**THE COUNTY OF GALVESTON**

**RE: ADDENDUM #2**  
**RFP #B121024, Juvenile Justice Center Boiler Replacement Project**

# **ATTACHMENT 1**

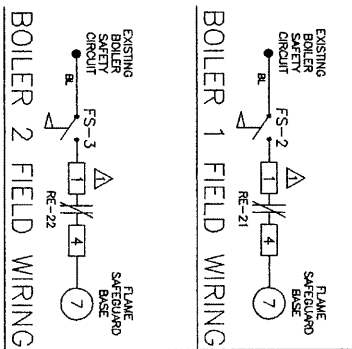
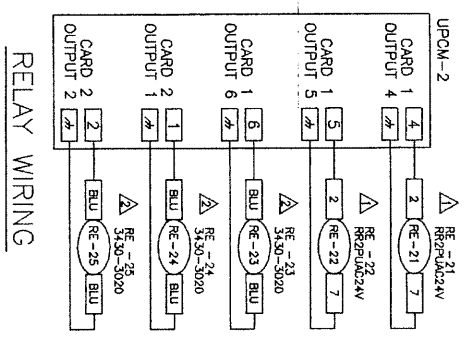
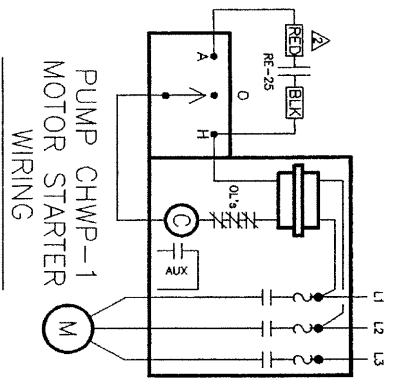
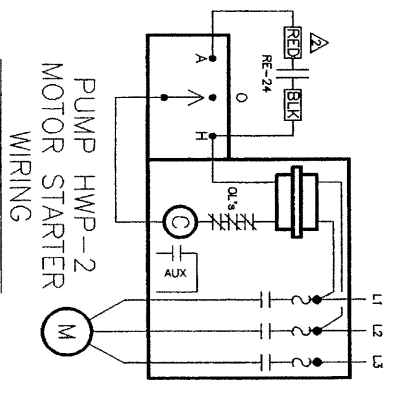
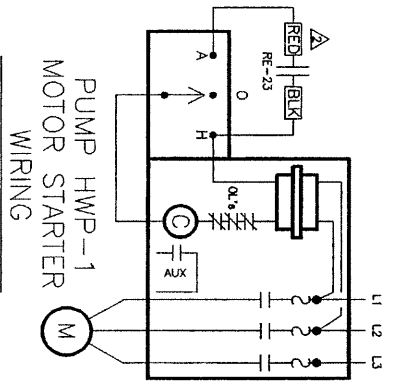
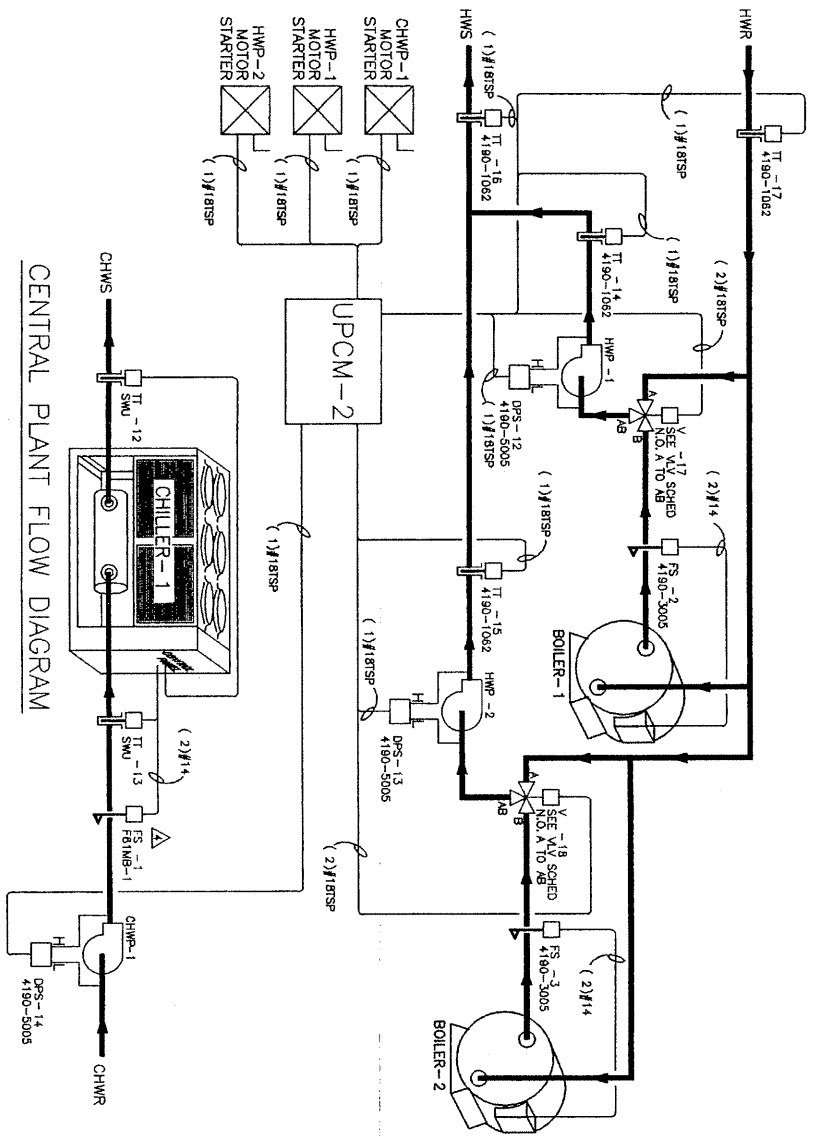
***Question #1: Is there an electrical drawing?***

Response: There are no new electrical drawings. See Attachment 1 for the original drawing for the existing boilers.

**M1.0**  
 SHEET NUMBER  
 PROJECT NO. 09-005

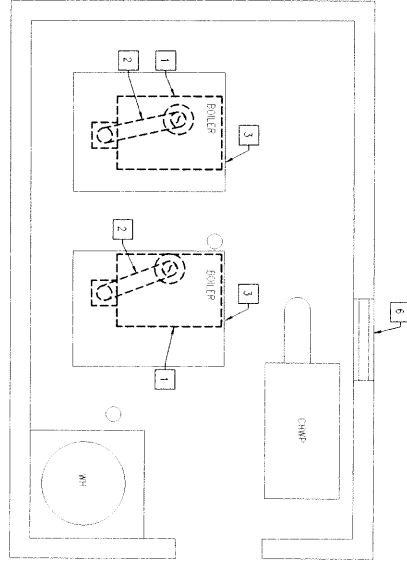
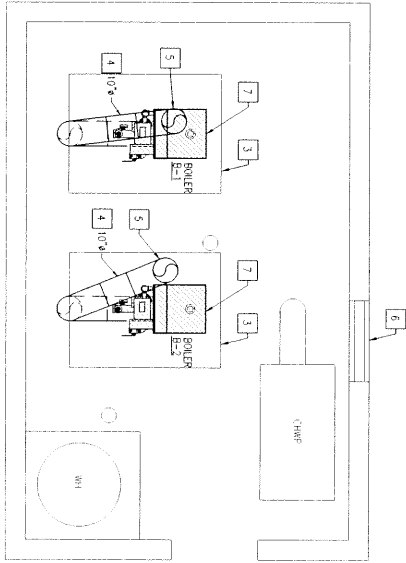
*However, the mechanical sheet M1.0 is not posted on ISQFT and that may have additional information and items that we would require to provide a proper quotation. Was this sheet left out in error, or does it not exist?*

*If it was left out will it be added prior to the bid date of 6/21/12?*

Response: Page M1.0 was inadvertently omitted from the plans. Please see Attachment 2, mechanical sheet M1.0.
